Response to Comments on the Draft 2 Criteria Analysis Report

ENERGY STAR® for Exterior and Interior Storm Windows

Figure 1: Distribution of certified glass options by emissivity and solar transmittance

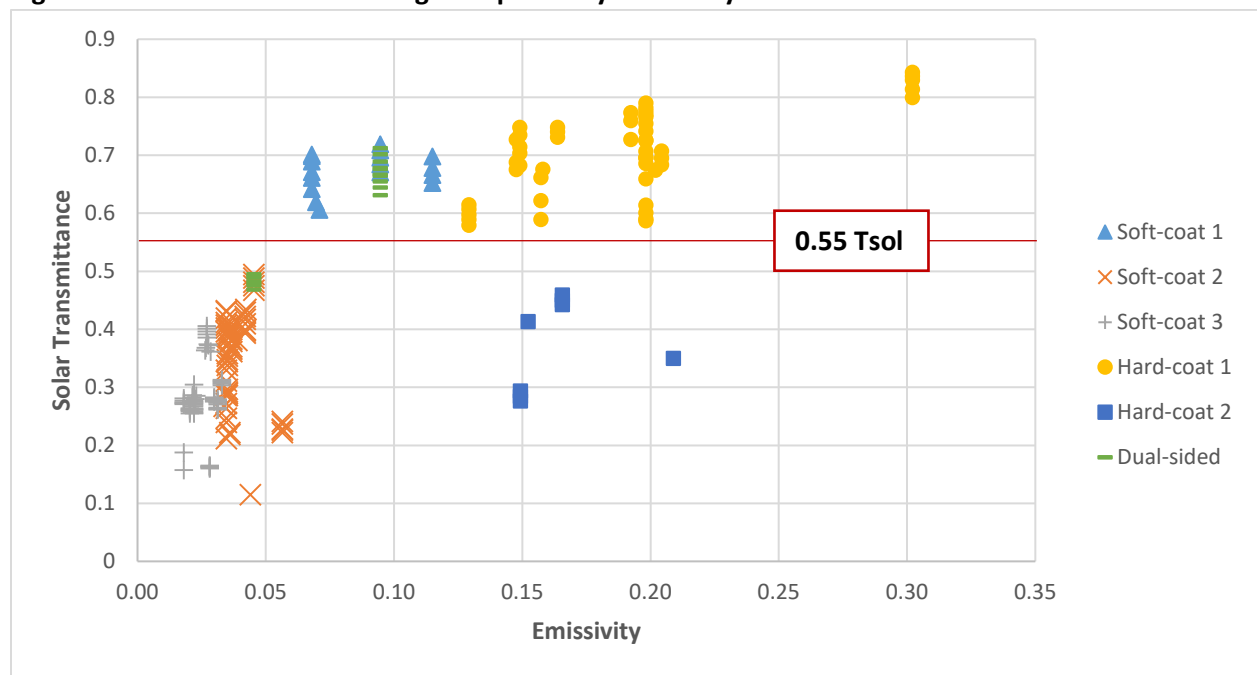
One commenter is concerned that the ENERGY STAR storm windows criteria are not sufficiently rigorous in comparison to ENERGY STAR windows. The commenter suggested that, if EPA is not going to eliminate climate zones, then EPA should provide greater differentiation between the two zones than simply using a solar transmittance value of 0.55. The commenter does not believe that calling 0.54 solar transmittance low solar gain and 0.56 solar transmittance high solar gain makes sense. The commenter also wondered why EPA used 0.46 solar transmittance in its analysis if it is going to set the criteria at 0.55 in the southern zone. They cited earlier EPA analysis that suggested that products with much lower

solar transmittance than 0.55 are available on the market, and asked if EPA examined whether additional cost-effective energy savings could be obtained from lower SHGCs than 0.55 or 0.46. Similarly, the commenter wondered why EPA used 0.69 and higher solar transmittance in its analysis if it is going to set the criteria at 0.55 in the northern zone. If the northern zone is to be limited by only high solar transmittance, they suggest at least using 0.65 as the minimum criteria.

EPA thanks the commenters for their support of the proposed criteria for solar transmittance in Draft 2. The proposed solar transmittance criteria for high and low solar transmittance represented a natural break in the performance distribution of products listed in the IGDB (See Figure 1). There are no applicable glazing options currently certified in the IGDB between 0.46 and 0.58 T_{sol}. In addition, the proposed requirement for the northern zone matches the current RTF regional specification. As previously stated, EPA believes that reinforcing existing market signals for this initial product category specification is beneficial to the market.
